**Subject:** Re: S. 16 Planning Application no. A/YL-KTN/1018 - Departmental Comments

**有關城市規劃委員會對 A/YL-KTN/1018 的查詢**

S.16 Planning Application No. A/YL-KTN/1018

Proposed Layout Plan

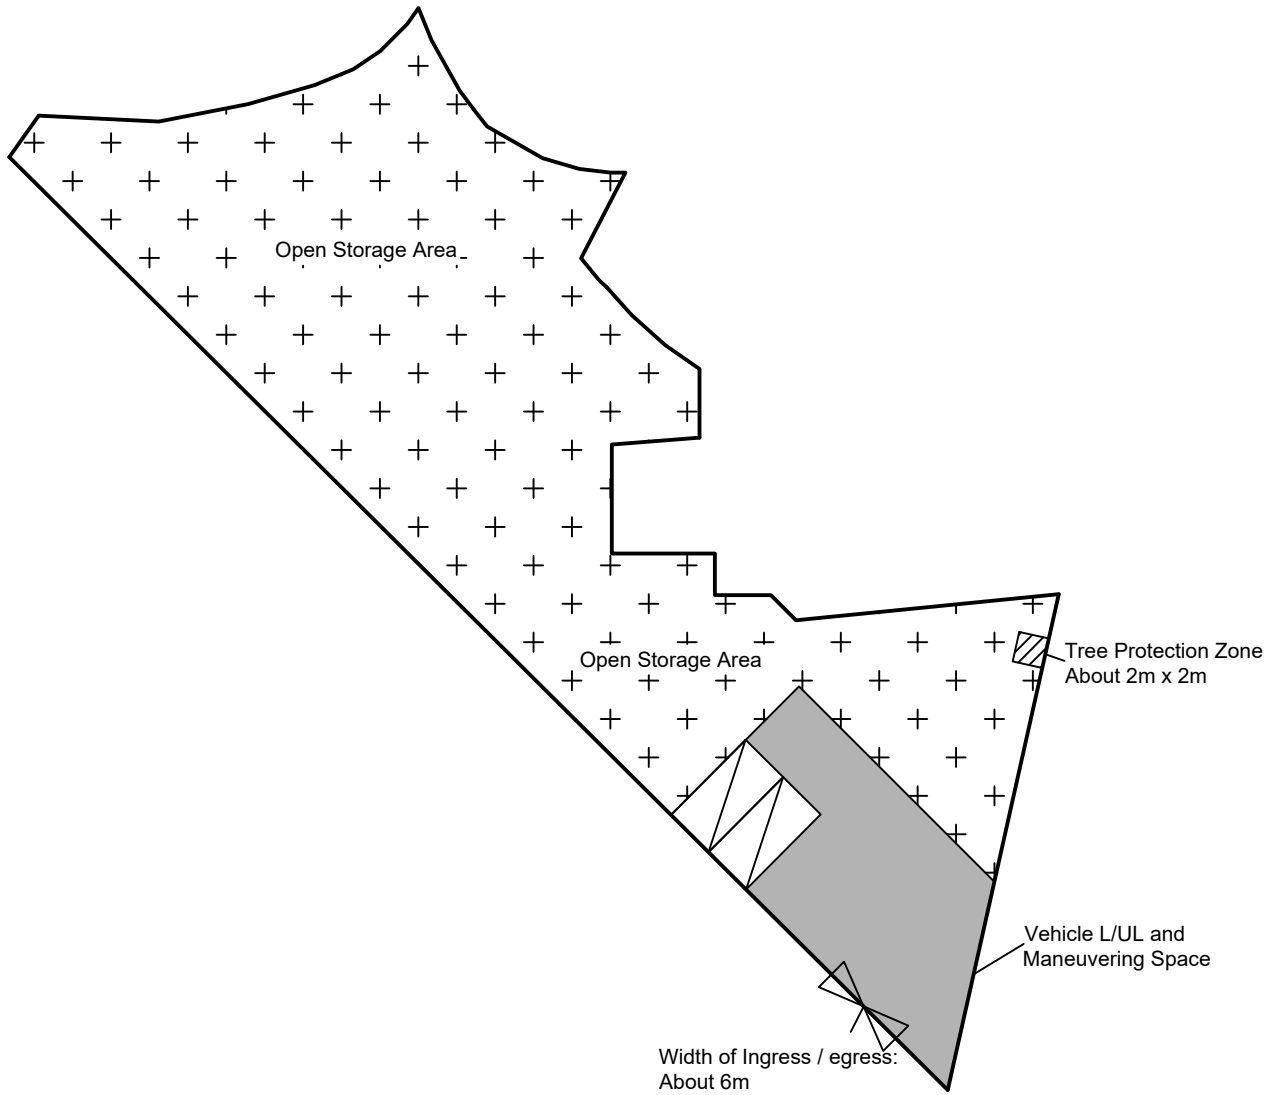
收悉 貴委員會對 A/YL-KTN/1018 申請的疑問，本人現書面回覆。

申請範圍約 1,559.1 平方米，當中有約 268 平方米為車輛上落區、車輛轉動區及樹木保護區，上述範圍不會用在露天存放。相關圖則請參考 Appendix 2 (2-02)。

Paved Area  
 平整位置圖

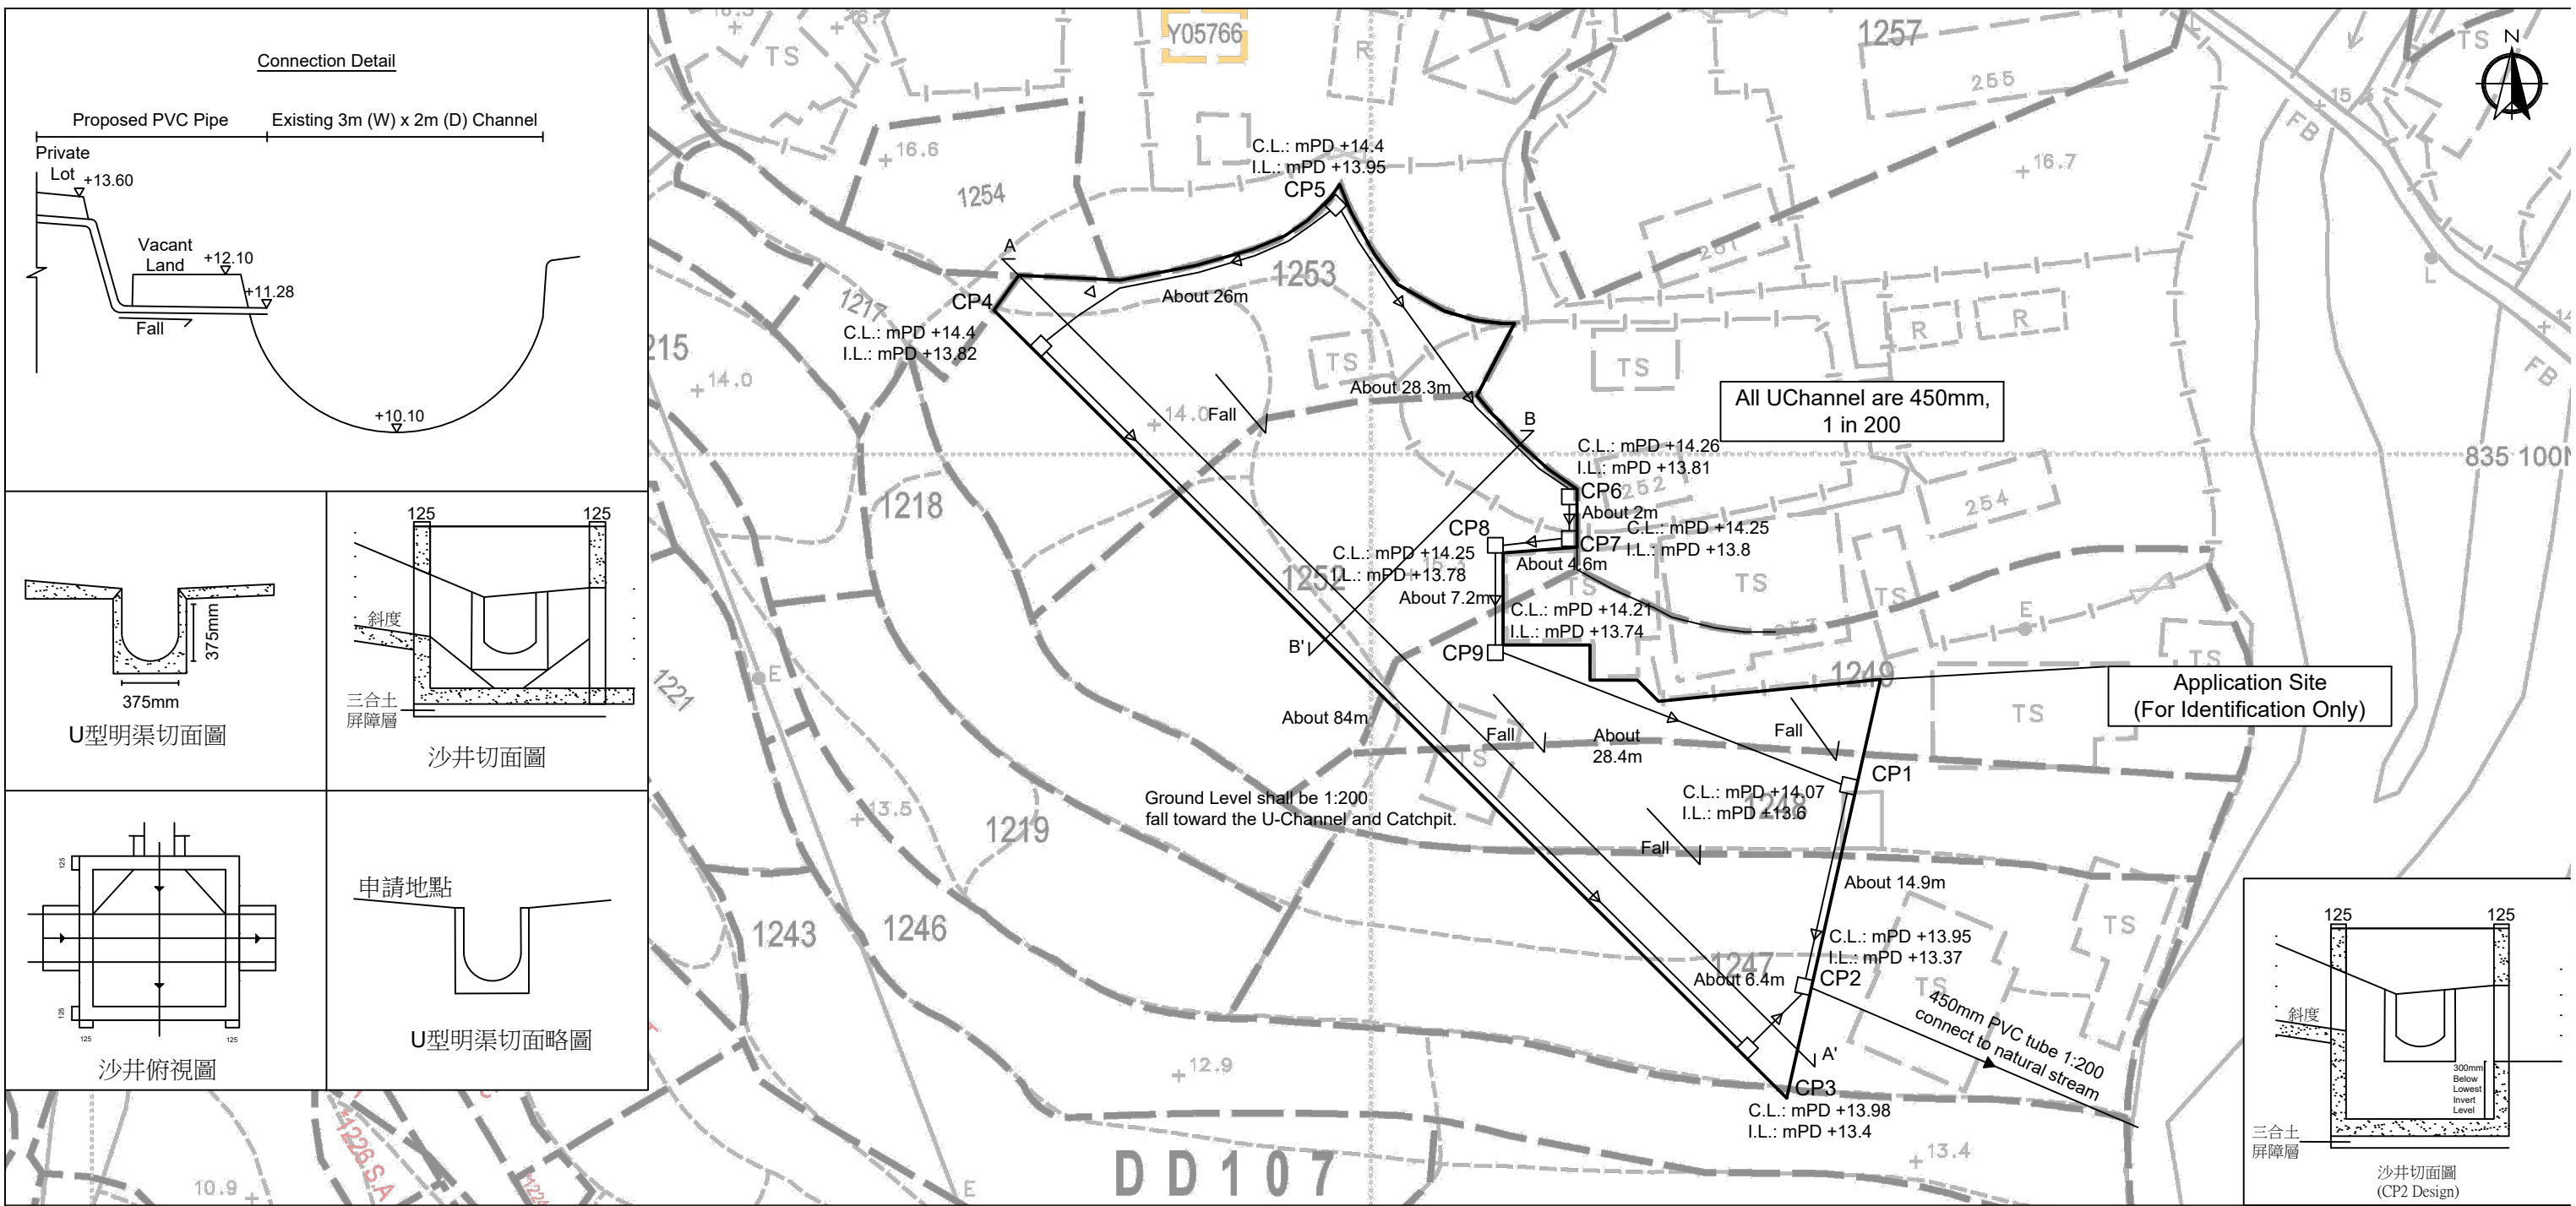
渠務署意見	申請人回覆
(1)	<i>The rainfall intensity is not correct. Please review the calculations.</i>	請參考 Appendix – Calculation，已修正該錯誤。
(2)	<i>Please provide all drainage facilities and hoarding/fencing with adequate opening, if any, in the section drawings.</i>	請參考 Appendix 5.1。
(3)	<i>Please justify the proposed catchment areas. The catchment areas should be determined according to existing topographic levels.</i>	請參考 Appendix 5.2 及 Appendix 5.3。
(4)	<i>Please advise if any site formation/ land filling works to be carried out under this application. Please note that the overland flow from the adjacent lands should not be affected.</i>	請參考 Appendix 4，填土及平整不會影響附近流水。

Existing Site Level: +14.2 mPD (About)  
 Proposed Site Level: +14.4 mPD (About)  
 Material of Filling: Concrete  
 Depth of Filling: 0.2m by Concrete (About)

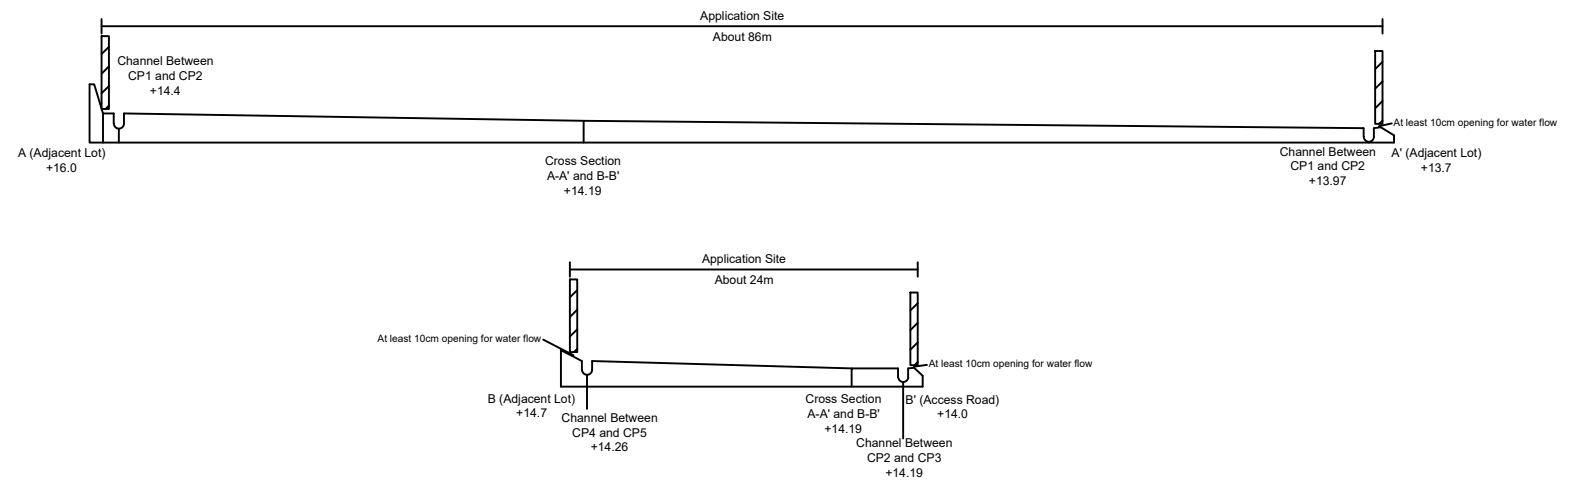
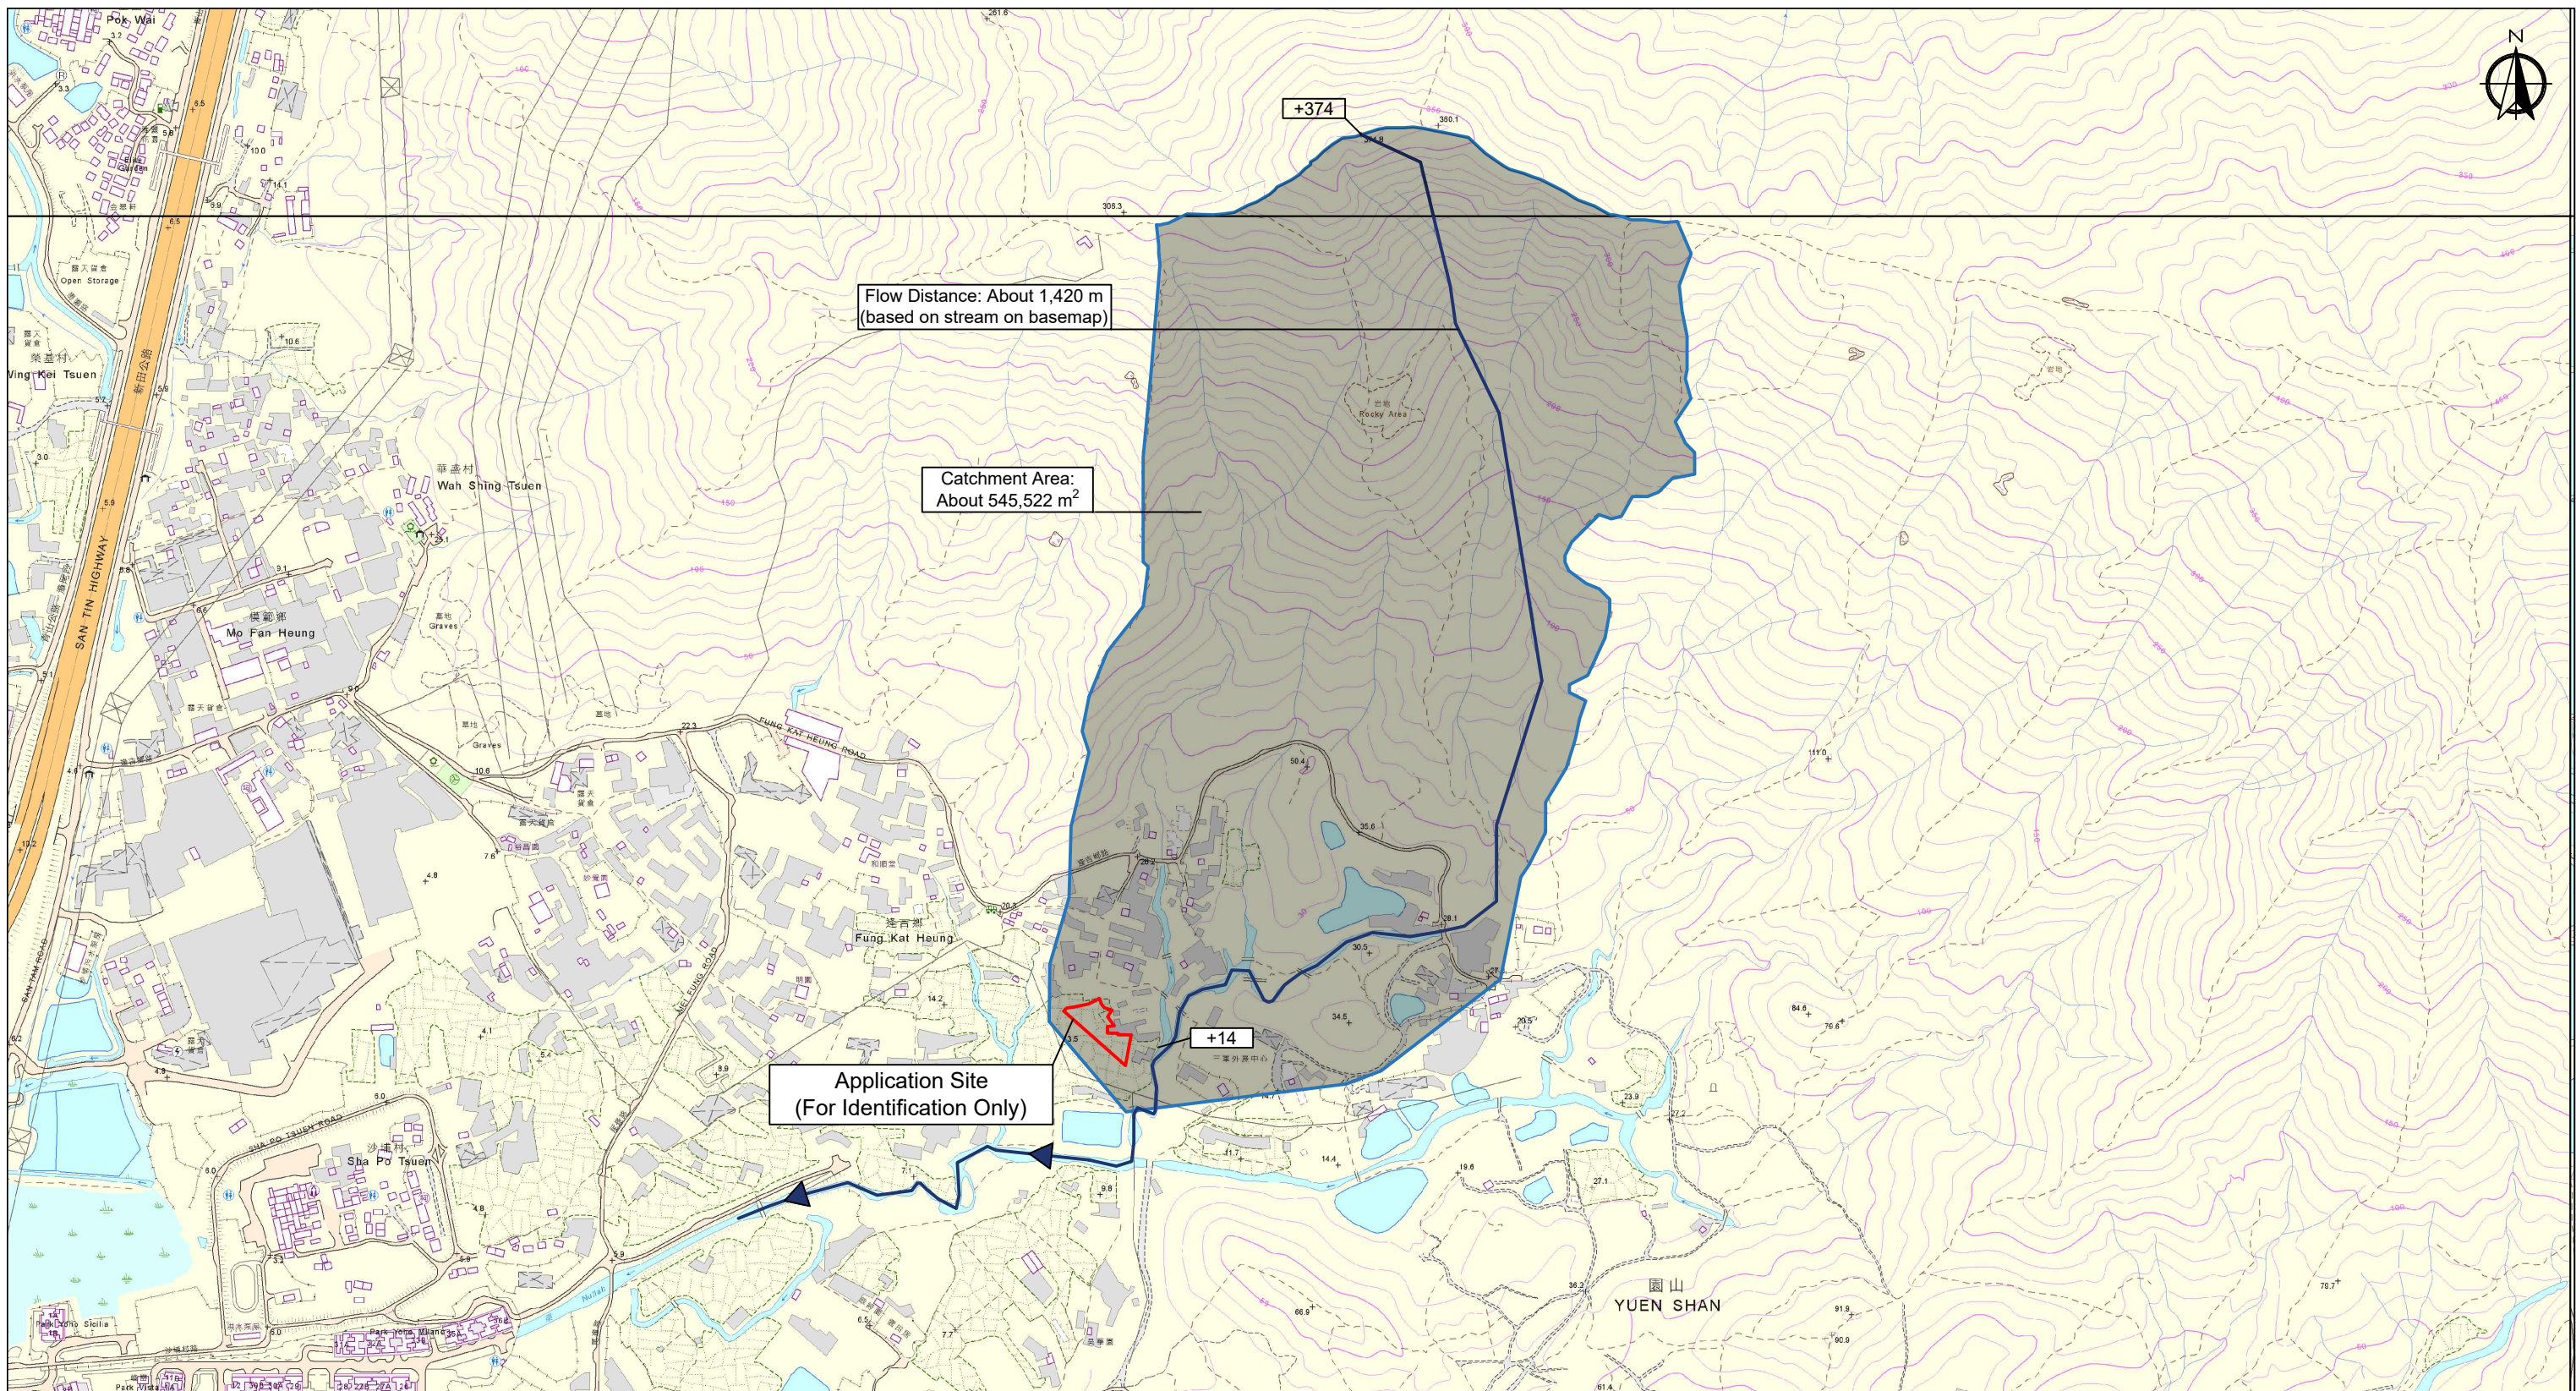
( 5 )	<i>Surface channels at the peripheral of the site should be constructed to intercept all such rain water falling onto the site.</i>	已依照 貴署的意見更改，請參考 Appendix 5。
( 6 )	<i>Please indicate clearly the full alignment of the discharge path from the application site all the way down to the ultimate discharge point (e.g. a well-established stream course/public drainage system).</i>	請參考 Appendix 5 及 5.4。
( 7 )	<i>Please review the all invert levels as it should be determined based on corresponding gradient proposed.</i>	已依照 貴署的意見更改，請參考 Appendix 5。
( 8 )	<i>The capacity checking of existing natural stream does not include the downstream flow.</i>	已依照 貴署的意見更改，請參考 Appendix – Calculation。
( 9 )	<i>The proposal should indicate how the runoff (the flow direction) within the site would be discharged to the proposed u-channel.</i>	已依照 貴署的意見更改，請參考 Appendix 5。
( 10 )	<i>The existing drainage facilities, to which the stormwater of the development from the subject site would discharge, are not maintained by this office. The applicant should identify the owner of the existing drainage facilities to which the proposed connection will be made. Also, DSD noticed that the proposed drainage connection(s) to the surrounding/downstream area(s) will run through other private lot(s). The applicant shall demonstrate that the proposed drainage construction / improvement / modification works and the operation of the drainage can be practicably implemented.</i>	本人了解現有的渠道設施不是由貴署所興建及保護。如興建及接駁到其他私人或其他有關政府部門的渠道，會向有關持分者或部分了解及取得同意後才會進行相關工程。

渠務署意見	申請人回覆
(1)	<i>SDM Corrigendum No. 1/2022 and 1/2024 should be considered.</i>	已依照 貴署的意見改用相關數據。
(2)	<i>Channel turning at acute angle (i.e. at CP3 and CP4) should be avoided wherever possible.</i>	已依照 貴署的意見更改，請參考 Appendix 5。
(3)	<i>The existing drainage facilities, to which the stormwater of the development from the subject site would discharge, are not maintained by this office. The applicant should identify the owner of the existing drainage facilities to which the proposed connection will be made. Also, DSD noticed that the proposed drainage connection(s) to the surrounding/downstream</i>	本人了解現有的渠道設施不是由貴署所興建及保護。如興建及接駁到其他私人或其他有關政府部門的渠道，會向有關持分者或部分了解及取得同意後才會進行相關工程。
